# HISTORIC AND DESIGN REVIEW COMMISSION

**HDRC CASE NO:** 2019-641  
**COMMON NAME:** 335 TRAIL  
**LEGAL DESCRIPTION:** NCB 6078 BLK 2 LOTS 9 THRU 14 & 17 THRU 20  
**ZONING:** MF-33  
**CITY COUNCIL DIST.:** 1  
**DISTRICT:** River Road Historic District  
**APPLICANT:** Mark Odom/Mark Odom Studio  
**OWNER:** David Morin  
**TYPE OF WORK:** Construction of a multi-family residential development  
**APPLICATION RECEIVED:** October 18, 2019  
**60-DAY REVIEW:** December 17, 2019  
**CASE MANAGER:** Edward Hall  
**REQUEST:**

# HDRC FINAL REVIEW / TRAIL STREET TOWNHOMES

Series 860  
Double Hung Window System

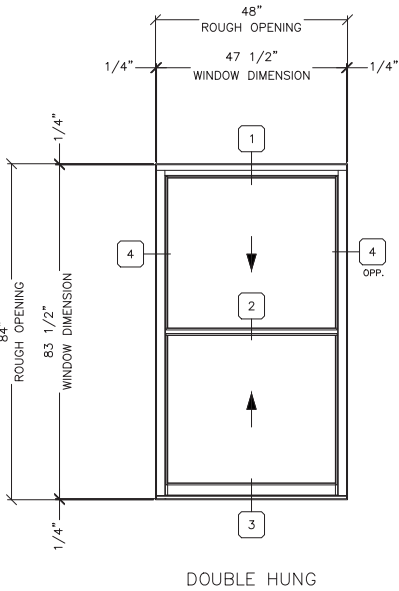
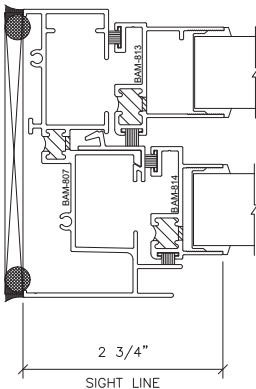
That the proposed aluminum clad wood windows feature **meeting rails that are no taller than 1.25"** and **stiles no wider than 2.25"**. White manufacturer's color is not allowed, and color selection must be presented to staff. There should be a minimum of two inches in depth between the front face of the window trim and the front face of the top window sash. This must be accomplished by recessing the window sufficiently within the opening or with the installation of additional window trim to add thickness. Window trim must feature traditional dimensions and architecturally appropriate sill detail. Window track components must be painted to match the window trim or concealed by a wood window screen set within the opening. The recessing of windows at least two inches within walls is also a requirement of the UDC Section 35-674.

**We propose to work with staff to find an acceptable black, aluminum window. Noting that staff is ok recommending alternative products if they are certain they meet the specs. (some aluminum-only products have been approved in the past). Our intention and details show that we will meet the depth requirements regardless of window type.**
